Technical Service Information

THM 325

SLIDE BUMP 1-2 AND 3-4 SHIFT

Figure 1

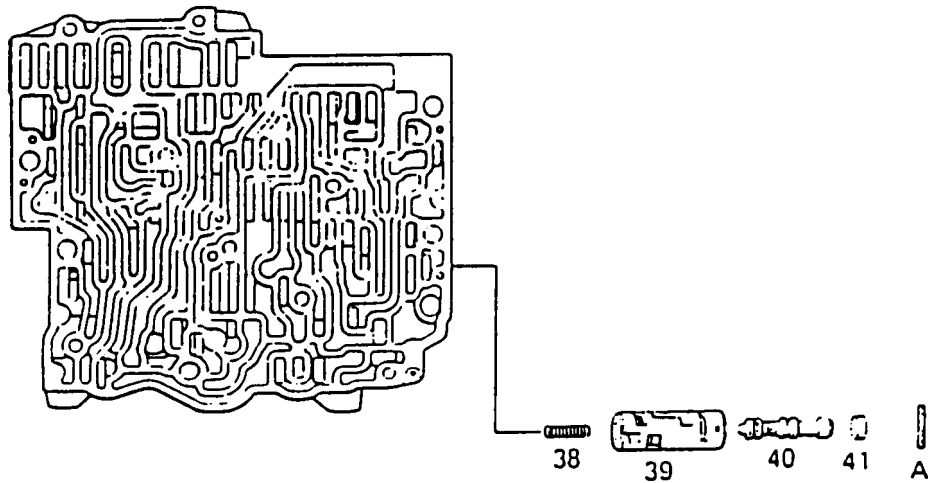
Some 1983 THM 325-4L AJ Model Transmissions may exhibit a slip bump 1-2 and 3-4 shift. A slip-bump is best described as a shift that starts out long and soft, but ends abruptly. This condition may be caused by the accumulator spring having slipped off the end of the accumulator valve. Beginning May 5, 1983, with transmission serial no. AJ=78258, a new control valve assembly went into production for the THM 325 4L AJ Model Transmission. This new control valve assembly has an accumulator valve (Figure 1), with a stem on the end of it that will retain and pilot the spring when it shifts. When servicing a 1983 THM 325 4L AJ Model Transmission built prior to transmission serial no. AJ=78258 for a slip bump 1-2 and 3-4 shift, order service part no. 8635969. Refer to Figure 2 and your service manual for the proper disassembly and reassembly of the accumulator valve train.
